# 1959 Corvette: Service Bulletin: Windshield Washers

**SUBJECT:** 1959 PASSENGER CAR  
WINDSHIELD WASHERS

**BULLETIN No.** DR #405

FIG. #1

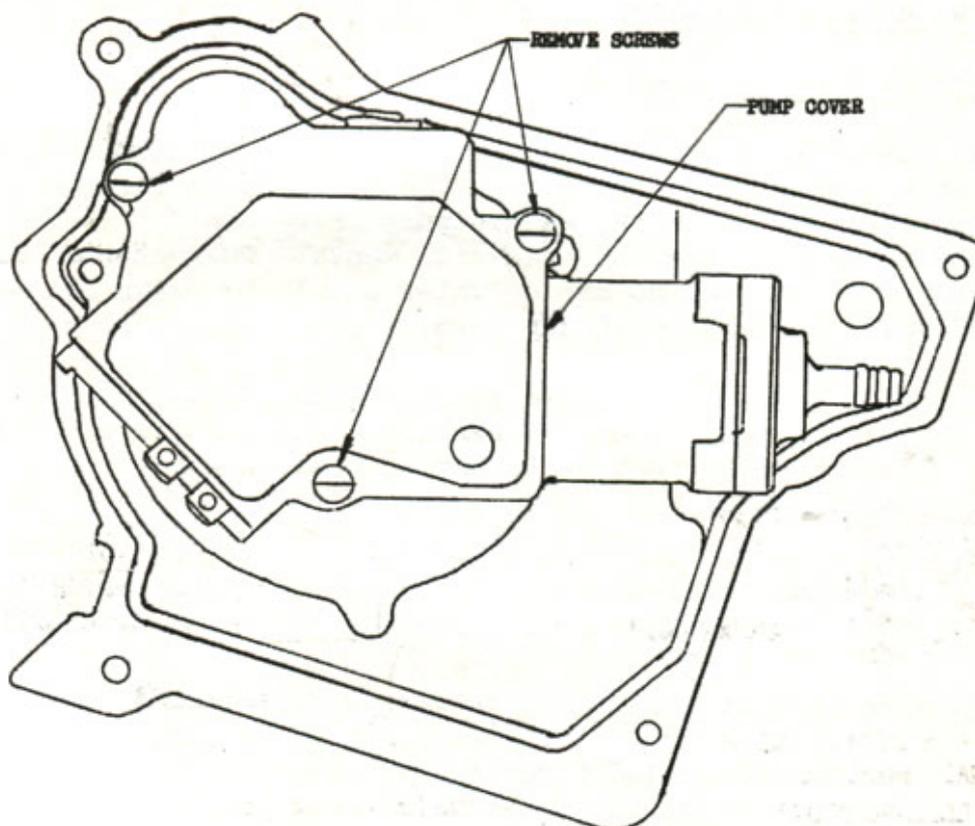
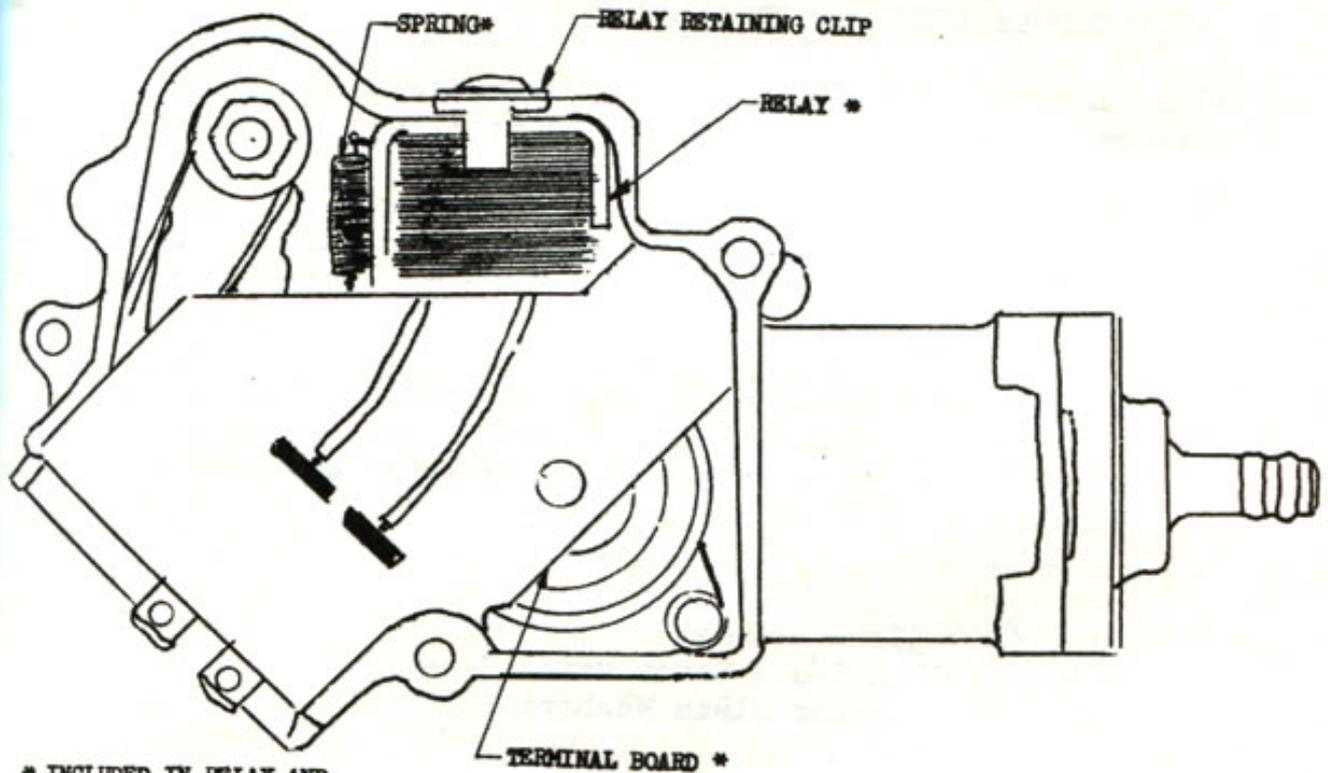
1. Remove pump cover. Cover is retained by three (3) screws. See Figure #1.
2. Lift terminal board up.
3. Pull relay out of pump body. Relay is retained by clip. Relay, armature and terminal board will come out together. See Figure #2.
4. Reinstall new Relay and Terminal Board Assembly, #4906055.

ARMATURE - LATE DESIGN  
FIG. #4

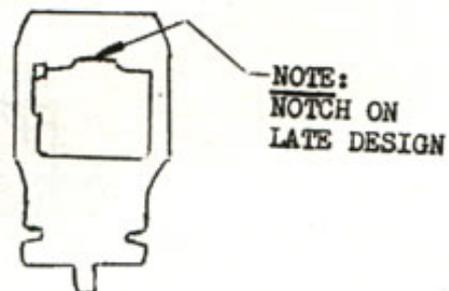
A few very early units may have a relay armature with a small opening or window which may contact the drive pawl. This could allow the drive pawl to push the armature up out of the park position and allow unit to recycle. Later armatures had a wider window and also a notch at end that contacts nylon gear. This notch prevented the drive pawl from catching top of ratchet tooth which also may cause unit to recycle. Later armatures incorporated additional features to maintain free movement and assume proper stop.

NOTE: See Figure #4, examples of early and late armature.

**CORRECTION:** Replace Relay and Terminal Board Assembly, #4906055 (late type armature is part of this assembly).

FIG. #6

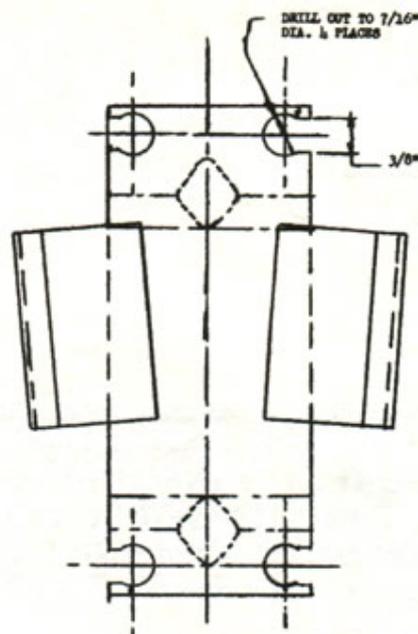
2. Drill out the four attaching holes in washer mounting bracket to 7/16". Cut away out board edge of attaching holes so grommet can be pressed into bracket. See Figure #6.

FIG. #7

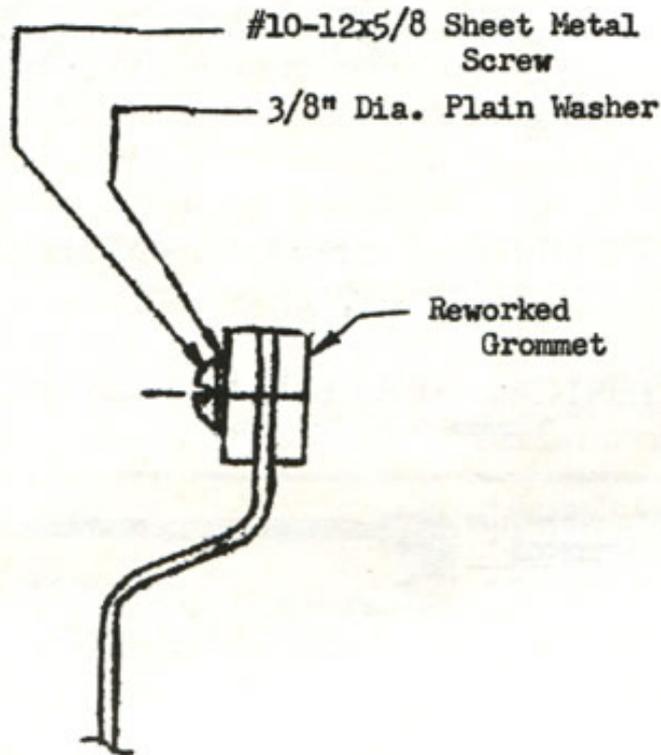
3. Place 3/8 diameter flat washers on front side of reworked grommets and attach bracket to dash. See Figure #7.
